City Council Agenda Item #10
Meeting of July 22, 2019

Brief Description	Resolution approving the preliminary plat of CONIFER HEIGHTS, 6-lot subdivision of existing properties at 5615 Conifer Trail and 5616 Mahoney Ave
Recommendation	Adopt the resolution approving the preliminary plat

MINNETONKA PLANNING COMMISSION
July 11, 2019

PROJECT NO.:	7775-0001
DWN BY:	JTP
CHKD BY:	JRA
APPD BY:	SKH
ISSUE DATE:	05-09-2019
ISSUE NO.:	2
SHEET TITLE:	PRE CONSTRUCTION EROSION CONTROL AND DEMOLITION PLANS
SHEET NO.:	C-201

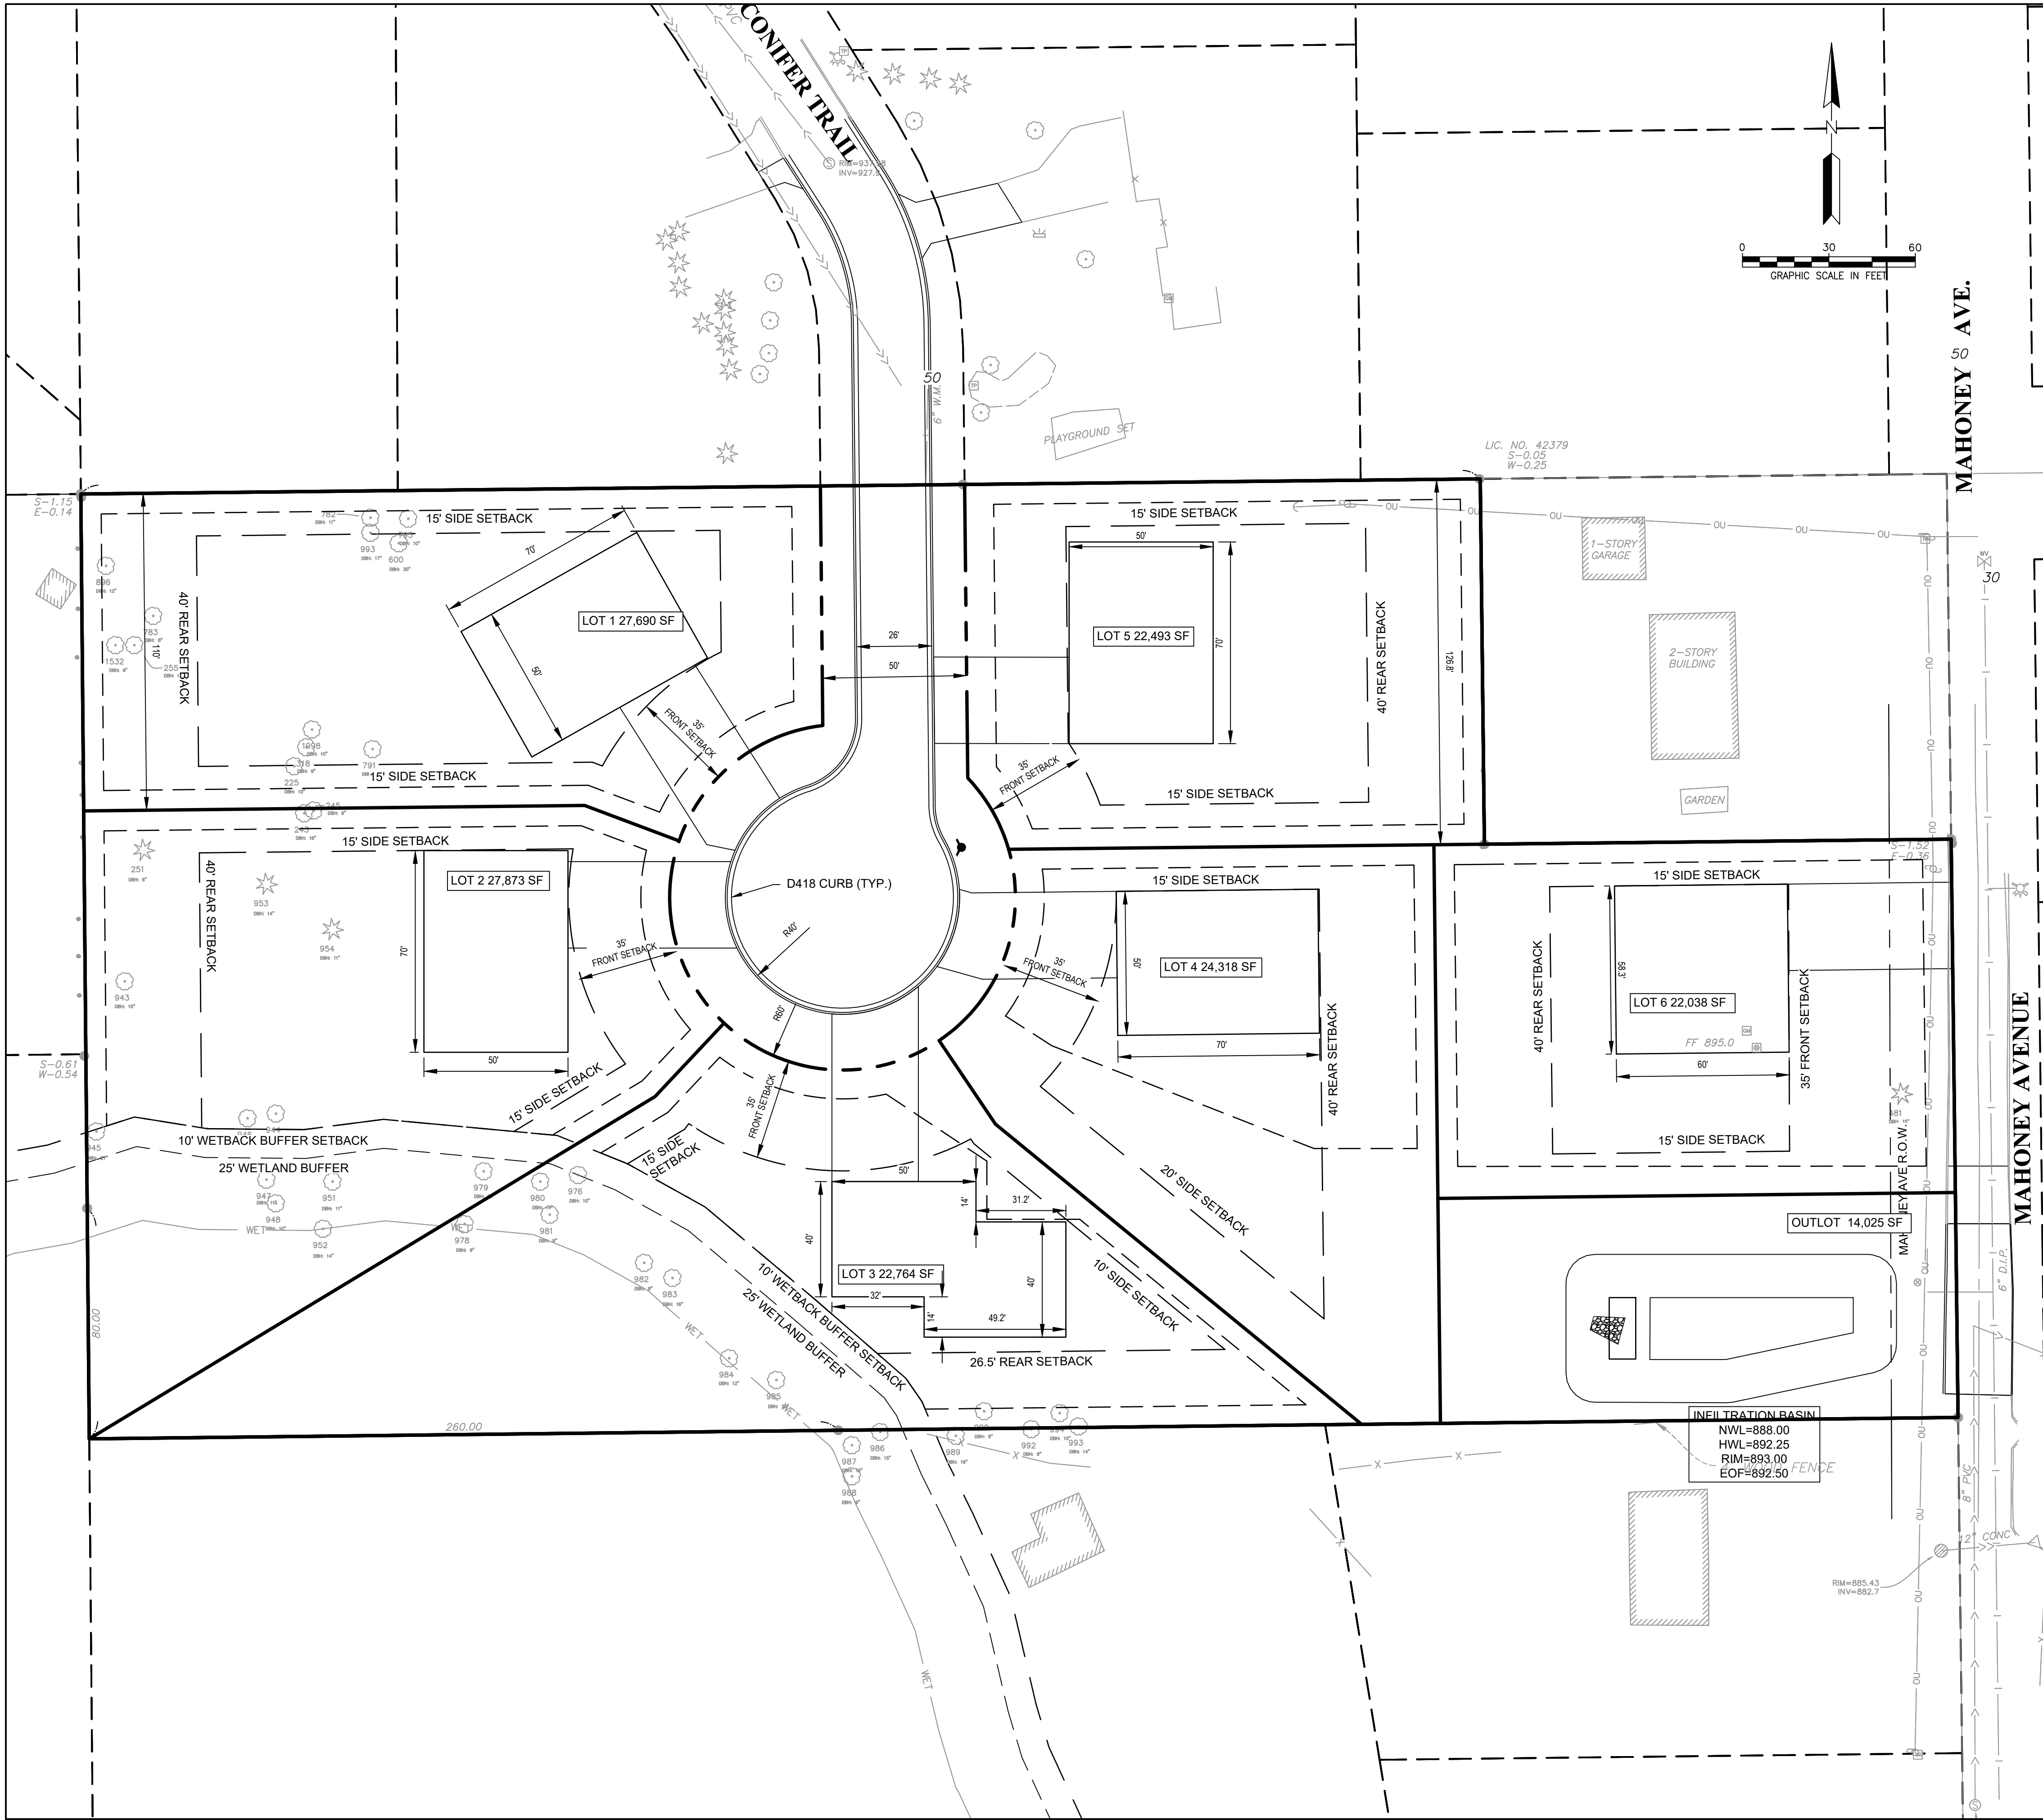
1) Lot 1 drawing on C-201 shows plans for the wire fencing outlining the property is planned to be removed. What is the reason for removal of this fencing? This borders on our property, and we are wondering why this fencing is slated to be removed?

- **Fencing:** This would be a question better suited for the developer. The city would not require the fencing to be removed nor require that it should remain onsite.

SHEET TITLE:
TREE PRESERVATION PLAN

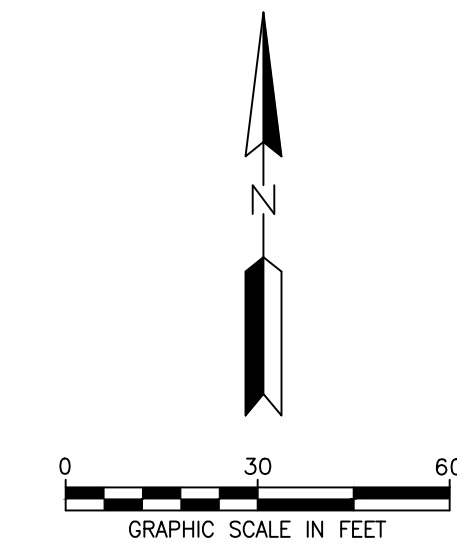
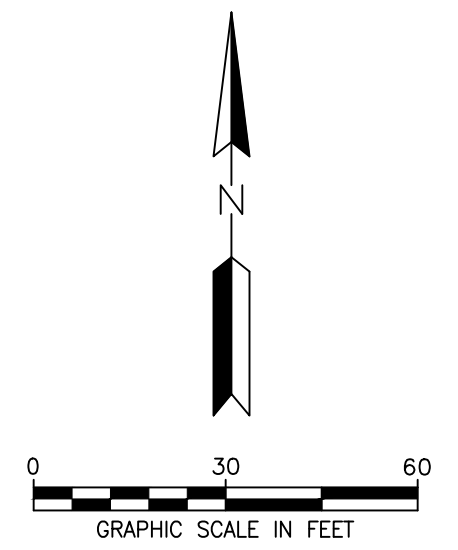
I understand from your report that the Tree Preservation Plan conforms with the ordinance. My question is if there can be some required mitigation (replacement) of trees removed in the shaded area which I hope you can see from the 2nd snip below.

Of course the trees will have to be removed for the construction. However I would like to see the developer required to place new trees--ideally conifers, but could be deciduous too--and/or other high-profile landscaped vegetation in the shaded areas below. It will actually be nice if they get rid of all the buckthorn, but then replace it with a mix of conifers and other vegetation to avoid our houses at the end (Dayhoffs, Baums, Sochas) from essentially being incorporated into a new multi-acre open yard with 4 of the 6 new homes. Note this is not in some hope that I wish that the new homes not be visible at all from my front yard. Instead it's that the new homes have adequate trees and other vegetation around them so that it doesn't lose the wooded feel and sightlines. I don't want to gamble on the new homeowners sharing this sentiment vs. the developer landscaping and replacing trees now.

- The applicant's tree preservation plan needs to add four trees.
- Once a property would be homesteaded for two years, then the property owner could remove trees like any other property.

- No more than four high priority trees can be removed.
 - Based on the submitted plans the mitigation requirements would be 19, two-inch trees.
- 4) Individual letters of credit or cash escrow for 125% of a bid cost or 150% of an estimated cost to construct streets and utility improvements, comply with grading permit, wetland restoration, tree mitigation requirements, and to restore the site. One itemized letter of credit is permissible if approved by staff. The city will not fully release the letters of credit or cash escrow until: (1) as-built drawings have been submitted; (2) a letter certifying that the streets and utilities have been completed according to the plans approved by the city has been submitted; (3) vegetated ground cover has been established; and (4) required landscaping or vegetation has survived one full growing season.

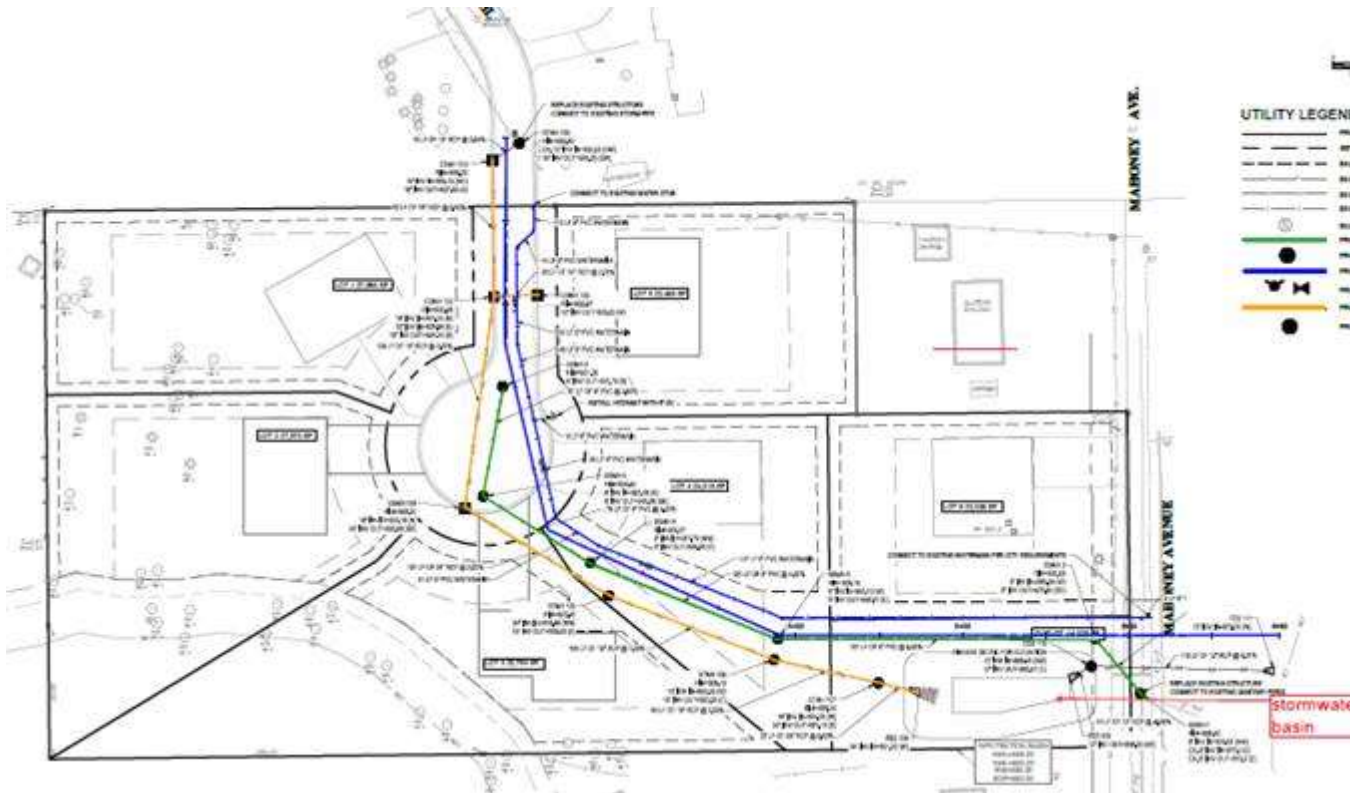
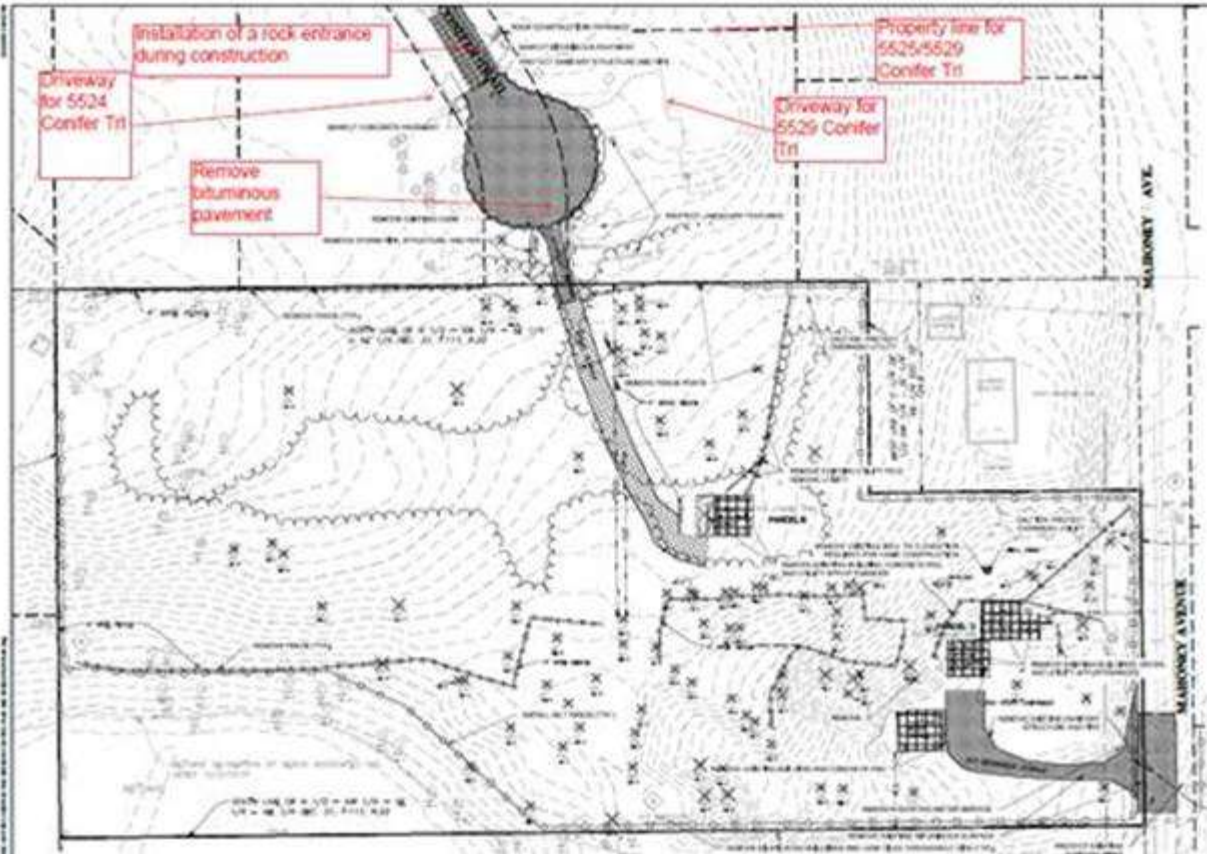
3). What are the plans for disruption on the current existing cul de sac with respect to extending sewer lines and water mains? will this require the street to be dug up and inaccessible for any periods of time?

- **Conifer Trail disturbance.** The existing cul-de-sac bulb of Conifer Trail is a temporary cul-de-sac and would be removed in order to construct the extension and install utilities. I hope that the plans below better articulate the anticipated disturbance. The developer will need to notify and coordinate with any impacted property owner if there is a brief closure required. However, usually they are short as the city wouldn't allow the developer to completely close access to your property for an extended period of time. You could contact the developer to better understand closures and impacts to your specific property.
